**100%
Schematic
Design Review
Report**

Northmead Primary School Moxhams Rd, Northmead NSW

Report Prepared for: RP Infrastructure – Joe Wood
Report Prepared by: Philip Chun Accessibility - Samuel Dikstein
Our Ref: AN024-017140
Date: 13th January 2025

Marked Plans

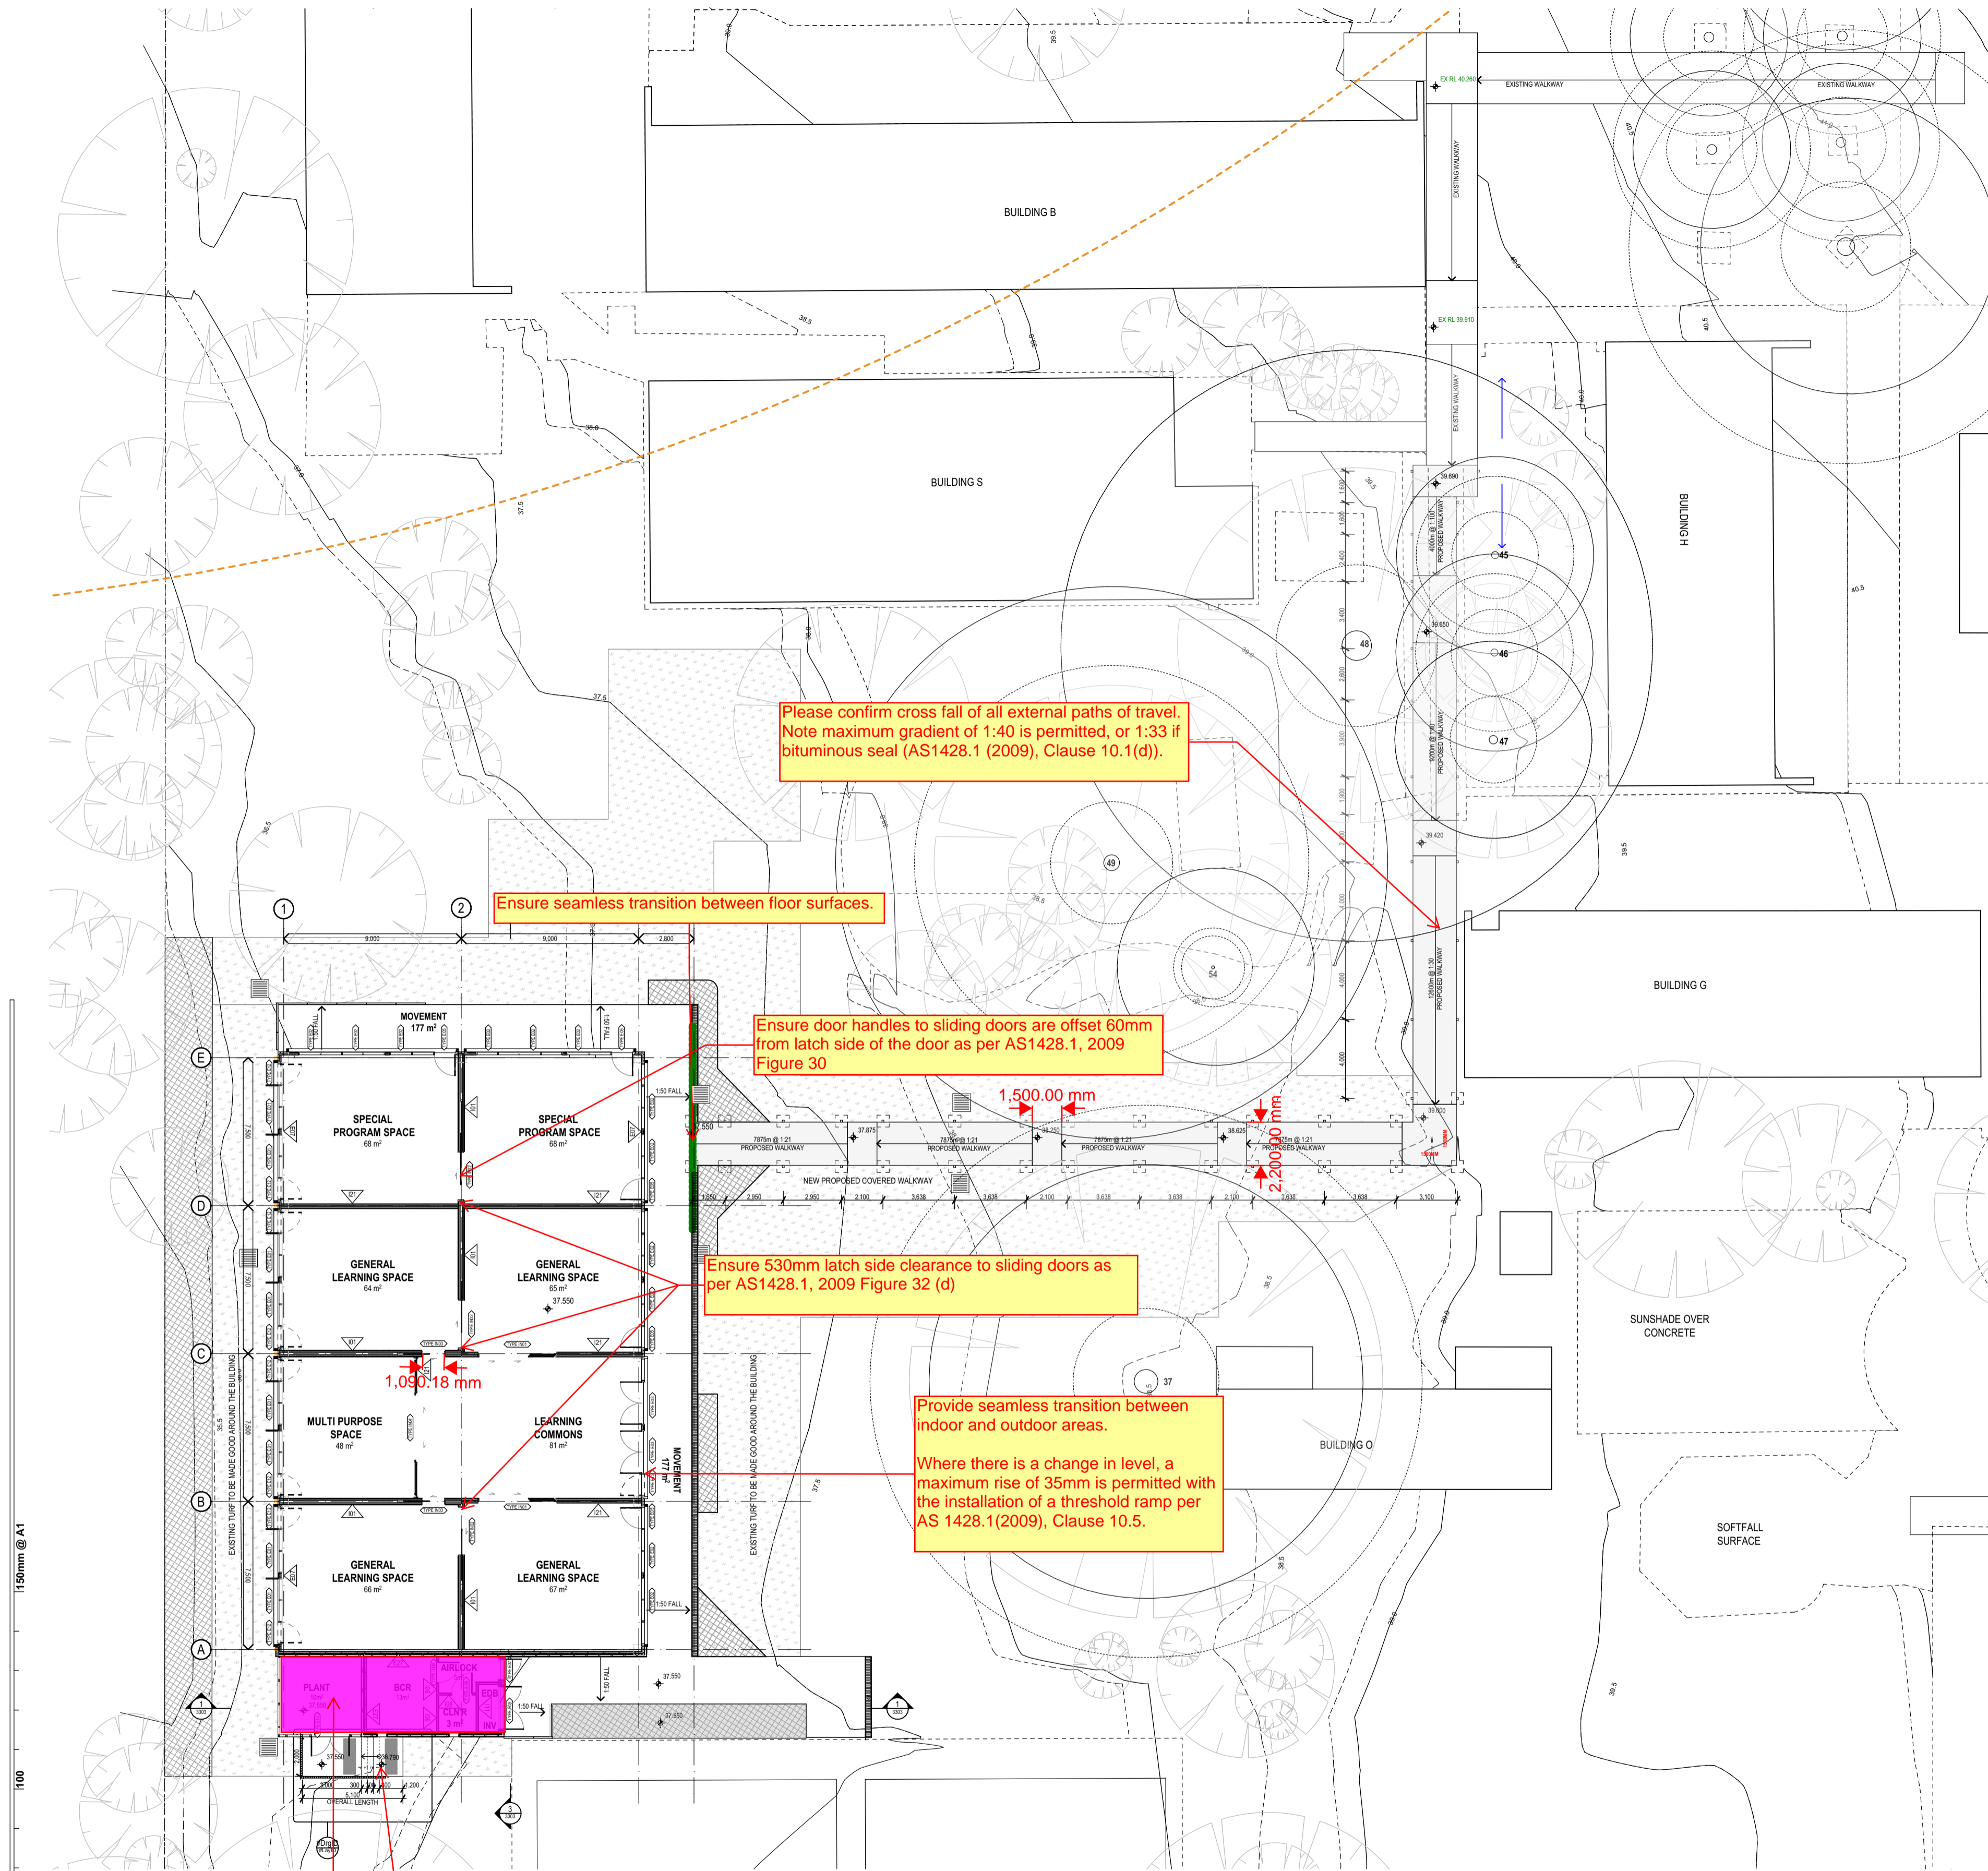
Frameless or fully glazed doorways and sidelights shall be clearly marked for their full width. Provide details of proposed visual indication for review, noting the following per AS 1428.1(2009), Clause 6.6.

- Visual indication to be a solid, non-transparent, contrasting line;
- Minimum 75mm thick;
- Lower edge to be located between 900mm and 1000mm AFFL; and
- Provide 30% luminance contrast when viewed against the floor surface or surfaces within 2m of the glazing on the opposite side.

1 PLAN COVERED WALKWAY - GROUND PLAN SCALE: 1:200

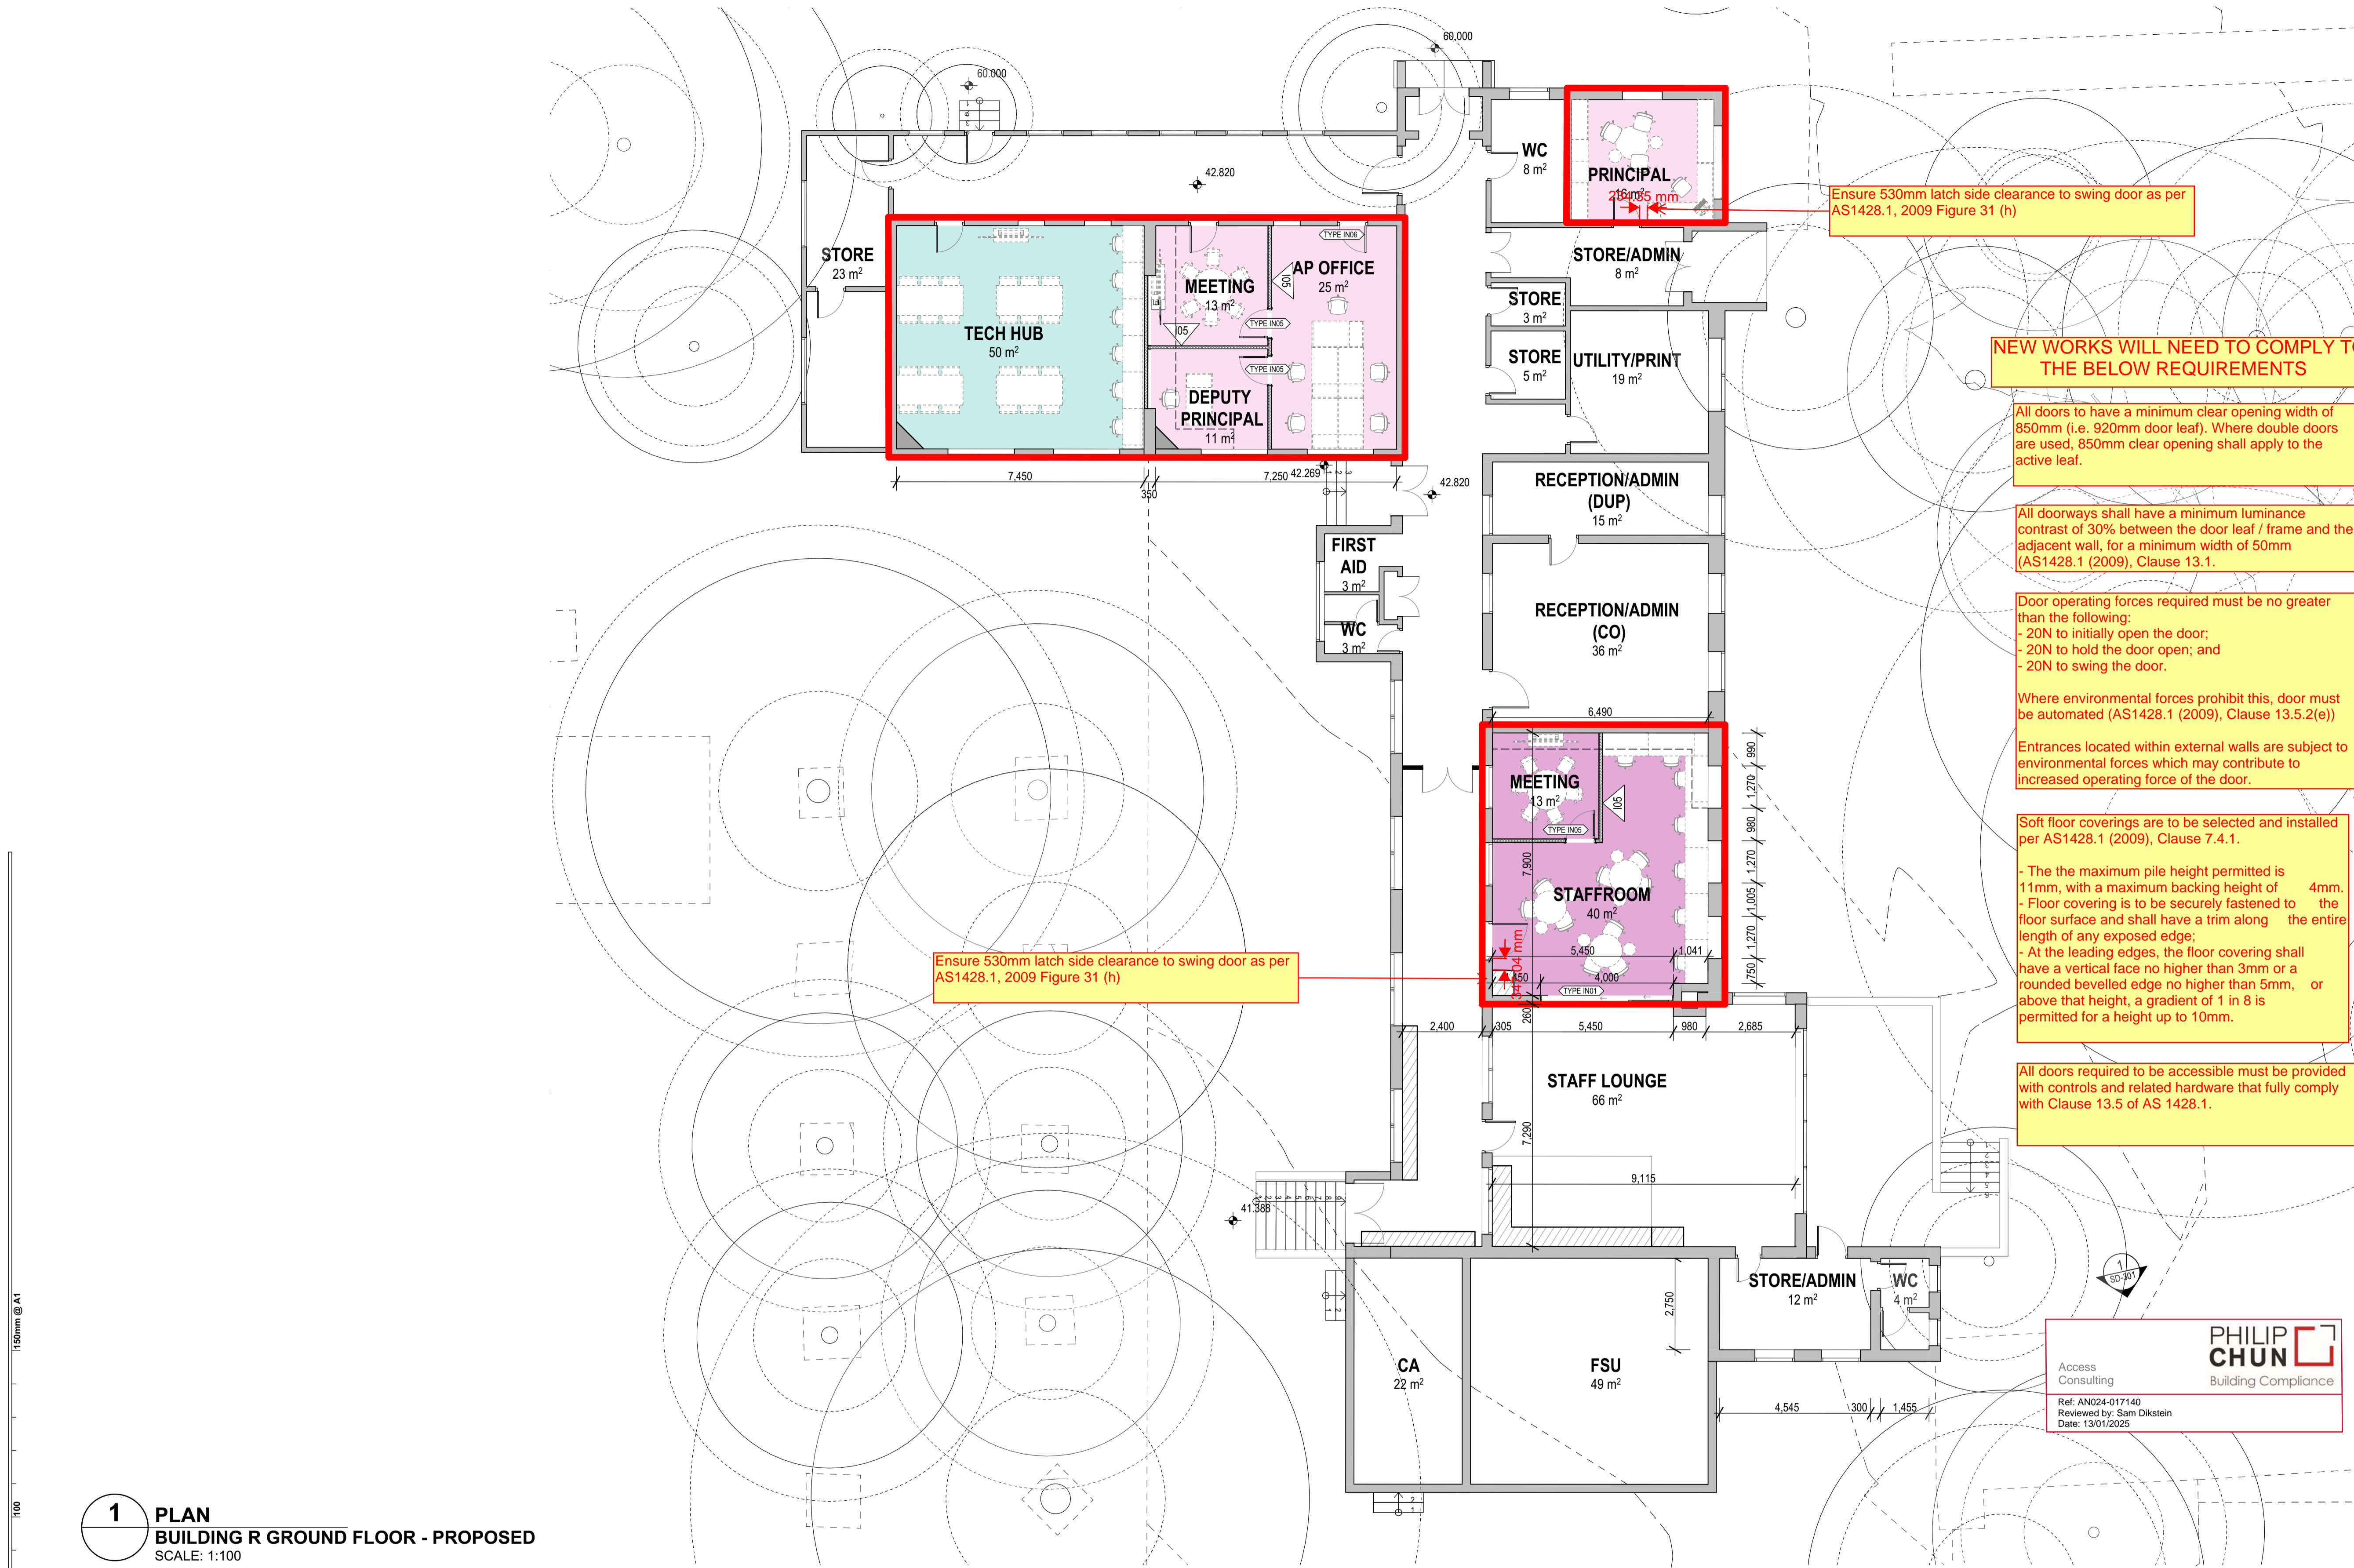
TGSIs are not required on a stair that leads to an area that is exempt under D4D5.
